Technical News 157
May 2014
Strictly Confidential

Item	Subject	Model Affected
Item 1.	Fork Oil Level	Thunderbird Commander and Thunderbird LT
Item 2.	Service Manual Amendment - Exploded View ABS System	Tiger Sport
Item 3.	Torque Change, Seat Infill Panel Locating Lug Fixings	Tiger Explorer and Tiger Explorer XC
Item 4.	Harness, Gear Position Sensor and Harness/ Gear Position Sensor Parts Kit	Rocket III Roadster
Item 5.	Torque Change, M10 ABS Hard Line Unions	Speed Triple ABS, Speed Triple R ABS and Sprint GT
Item 6.	Front Fork Disassembly and Assembly	Daytona 675 Models from VIN 564948 and Street Triple Models from VIN 560477
Item 7.	New Packing Crate and Footboard Reassembly	America
Item 8.	Main Frame Parts Kit	Daytona 675 Models from VIN 564948 and Street Triple Models from VIN 560477
Item 9.	Torque Change, Clutch Cover Fixings	Daytona 675 and Daytona 675R from VIN 564948
Item 10.	ABS Front Brake Line	Tiger Sport, Tiger 1050 ABS

Description: Service Manual Amendment - Exploded View ABS System

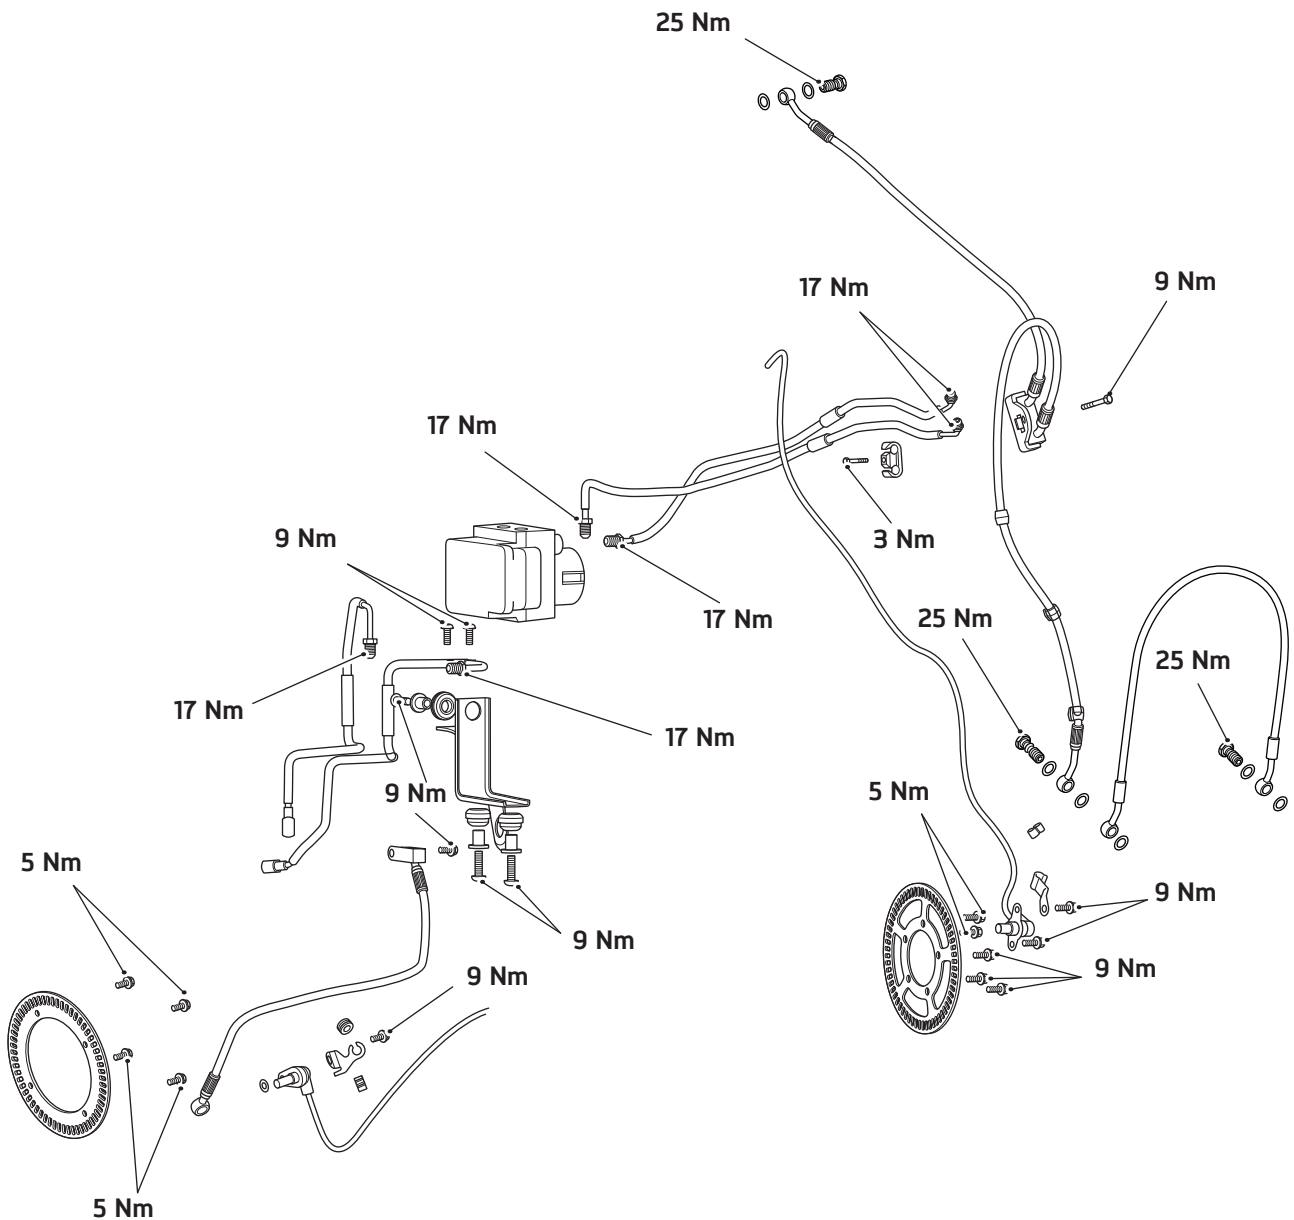
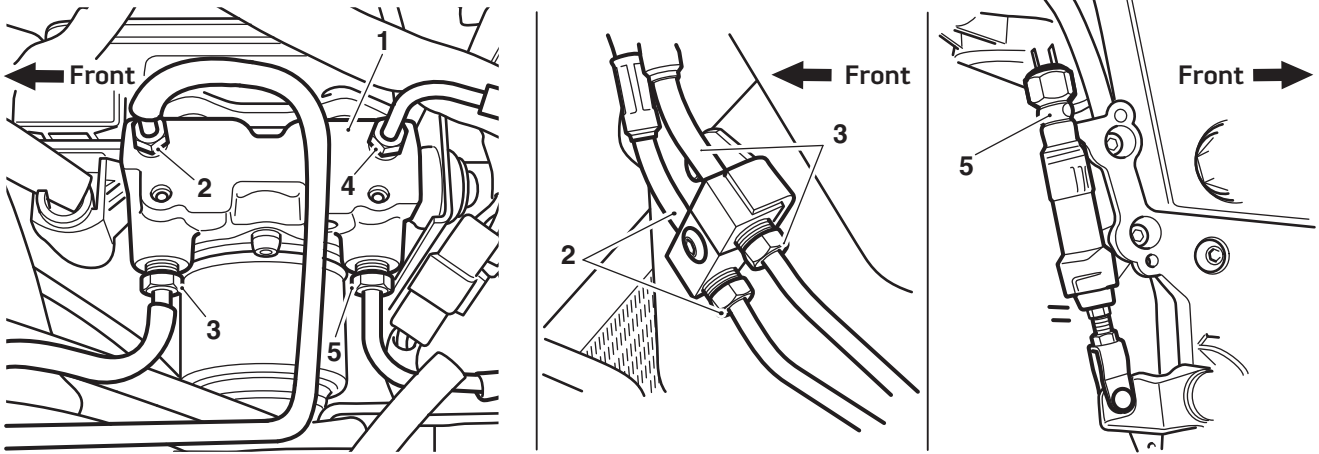
The exploded view of the Tiger Sport ABS system in the above Service Manual shows the incorrect routing of the ABS hard lines between the ABS modulator and the front brake lines. The following illustration must replace the current one as an amendment to the Service Manual.

If for any reason the brake lines are removed they must be connected as shown below.

1. ABS modulator
2. ABS modulator to front brake caliper
3. ABS modulator to front brake master cylinder
4. ABS modulator to rear brake caliper
5. ABS modulator to rear brake master cylinder

Description: Torque Change, Seat Infill Panel Locating Lug Fixings

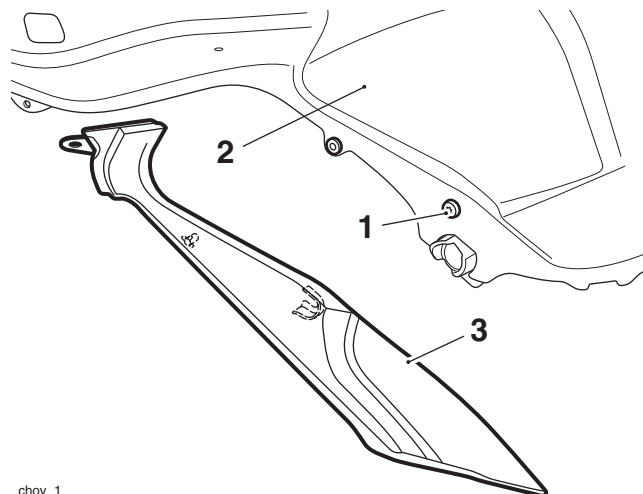
The torque figure for the seat infill panel locating lug fixings has changed to **9 Nm** on the above models. The locating lug fixings are positioned on either side of the fuel tank as shown below.

- choy_1
1. Seat infill panel locating lug fixing (left hand shown, right hand similar)
 2. Fuel tank
 3. Seat infill panel

Circuit Diagrams

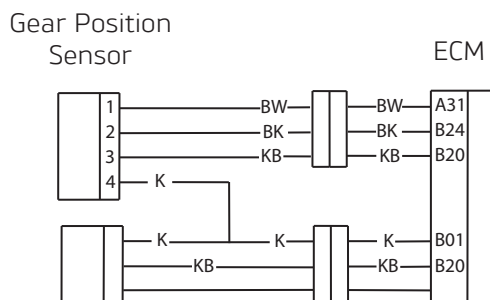
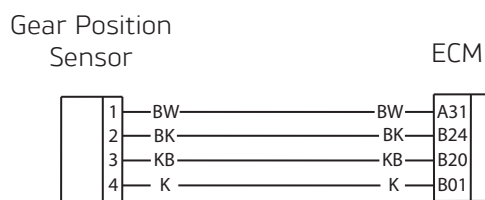
A new harness and gear position sensor have been released for Rocket III Roadster models from engine number 651833. The new gear position sensor is fitted with a long electrical lead which is now connected directly to the main harness without the use of a fly lead.

The gear position sensor pinpoint test procedure has also changed. The pinpoint test procedure for the new gear position sensor and old gear position sensors with a fly lead is as follows:

Description: Torque Change, M10 ABS Hard Line Unions
Models affected: Speed Triple ABS, Speed Triple R ABS and Sprint GT

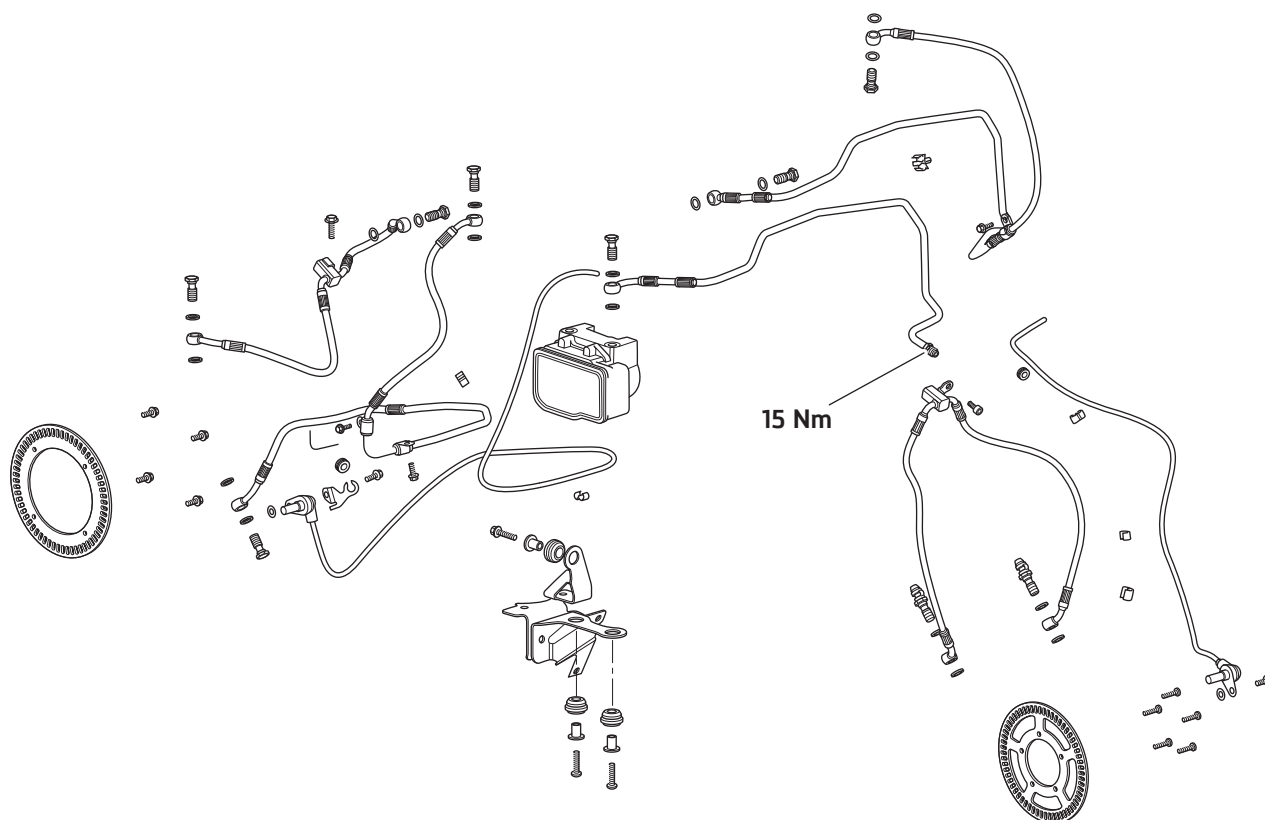
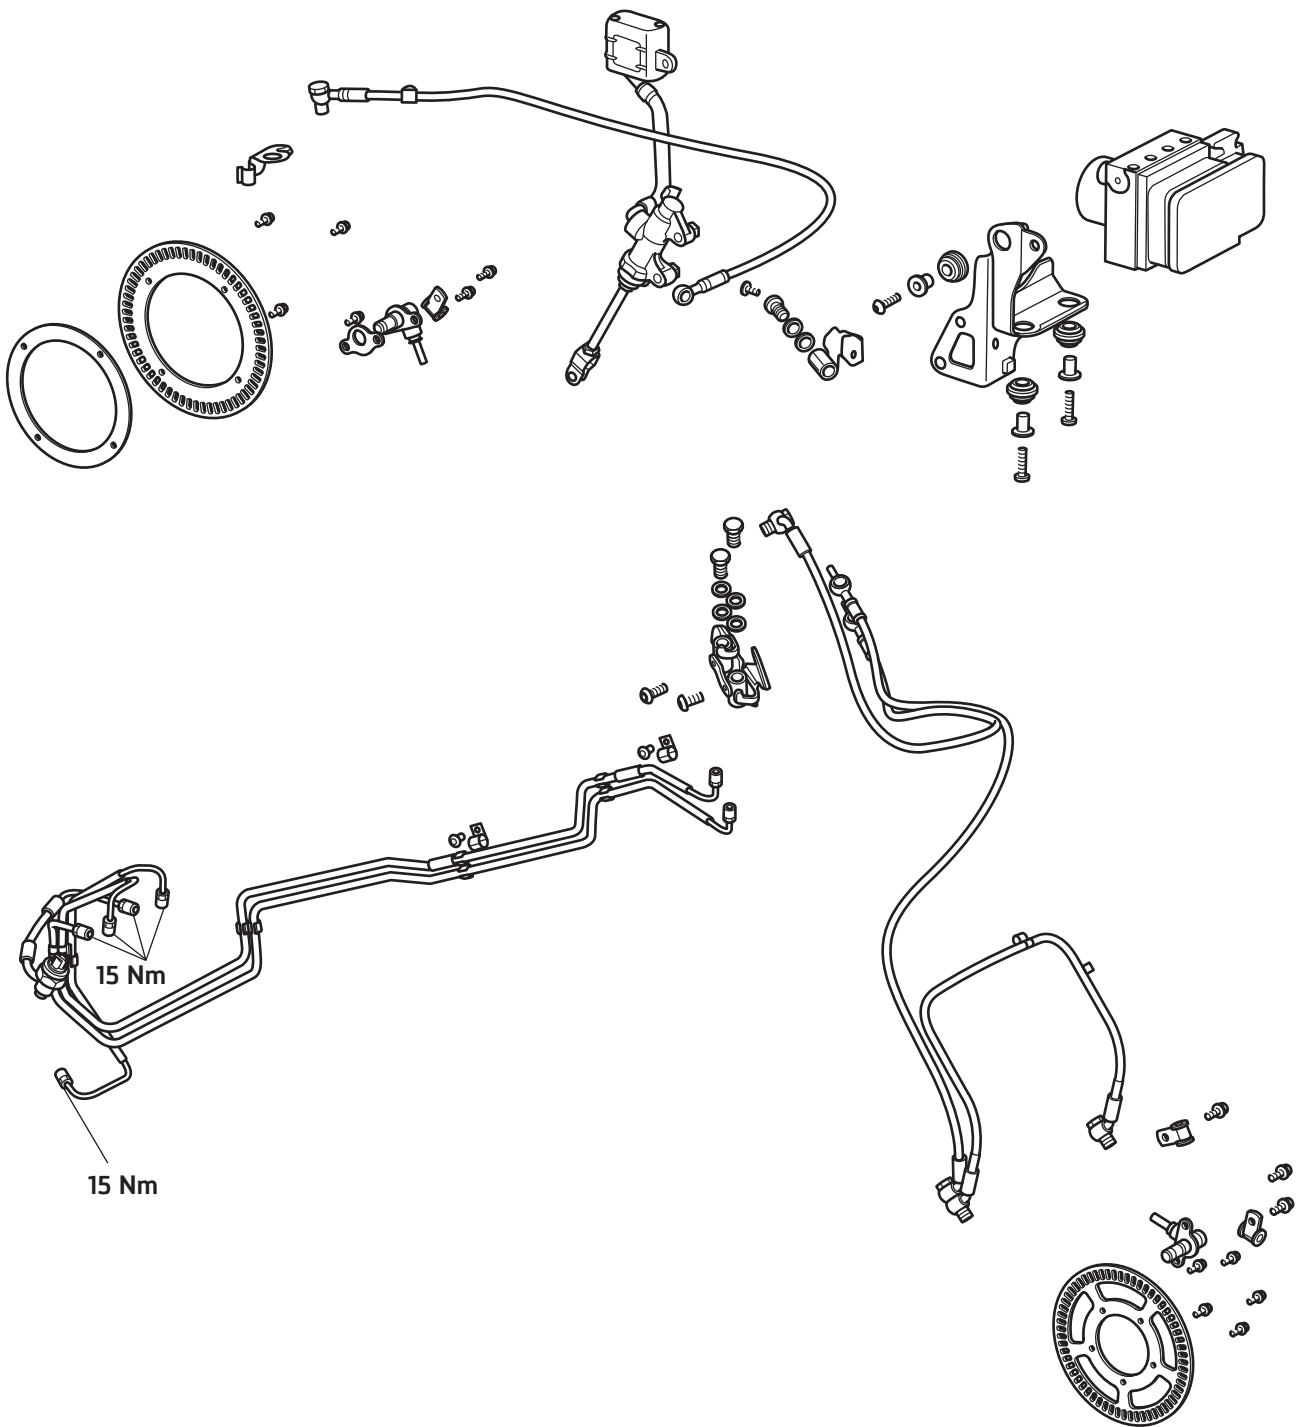
The torque figure for the M10 ABS hard line unions has changed to **15 Nm** on the above models.

- Models already in service need not be retightened unless the fixings have been loosened or removed.
- Only the torque figures for the M10 ABS hard line unions have changed. The torque values for all other fixings pictured in the following illustrations remain the same.

Description: Main Frame Parts Kit

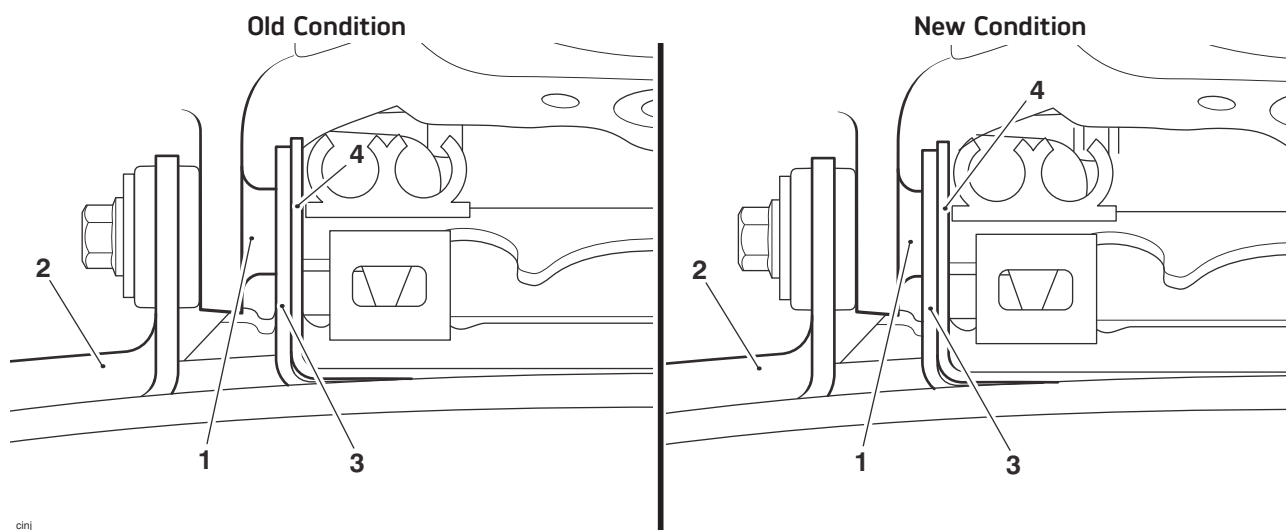
The radiator mounting bosses on the main frame have been modified on the above models from VIN 626498. The two mounting bosses are now thicker, which reduces the distance between the two bosses.

This change does not affect the mounting of the radiator but the rubber air deflector and its retaining plate have also been modified because of the distance between the two bosses.

Clutch Cover Tightening Sequence

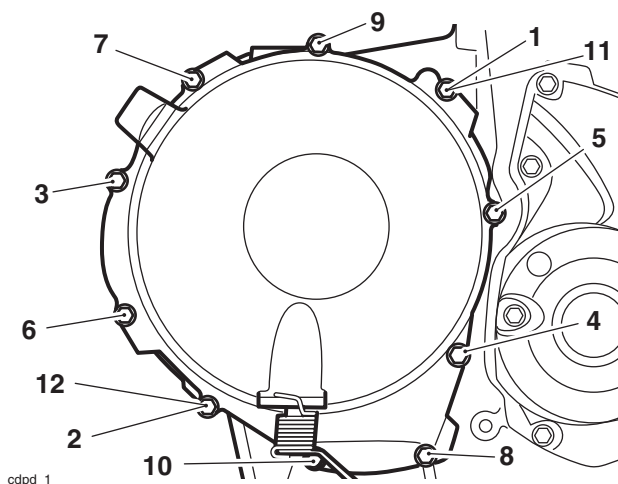
The torque figure for the clutch cover fixings has changed to **11 Nm** on the above models. If for any reason the clutch cover fixings are loosened or removed:

- Discard the copper washer located on fixing number four.
- Fit a new copper washer.
- Retighten the fixings to **11 Nm** in the sequence shown below.

New Condition Hard line

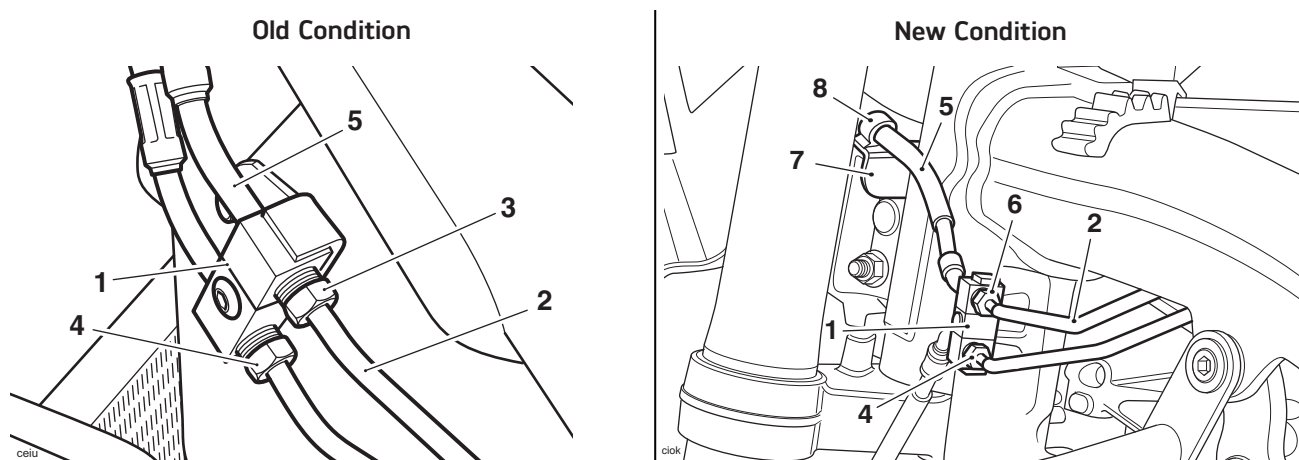
The following new ABS items have been introduced to the above models from VIN 650174:

The new condition hard line has a M12 union for the front brake line connector housing; the union for the ABS modulator end remains the same at M10.

- M12 union is **19 Nm**.
- M10 union remains at **15 Nm**.
